ADA Curb Ramp New Construction Inspection Form (Parallel)

NW Timeric

24952.54

NW North Ave

PARALLEL RAMP (PL)

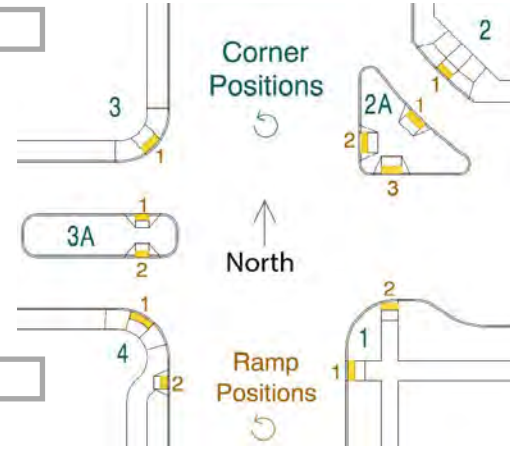
9.7 $\leq 2.0\%$ ☐ $> 2.0\%$ ☒

4.1 $\leq 2.0\%$ ☐ $> 2.0\%$ ☒

N Y ☐ N ☒

4.1 $\leq |5.0\%|$ ☐ $> |5.0\%|$ ☒

N Y ☐ N ☒

7.2 $\leq 2.0\%$ ☐ $> 2.0\%$ ☒

7.7 $\leq 2.0\%$ ☐ $> 2.0\%$ ☒

3.9 $\geq 4.0'$ ☐ $< 4.0'$ ☒
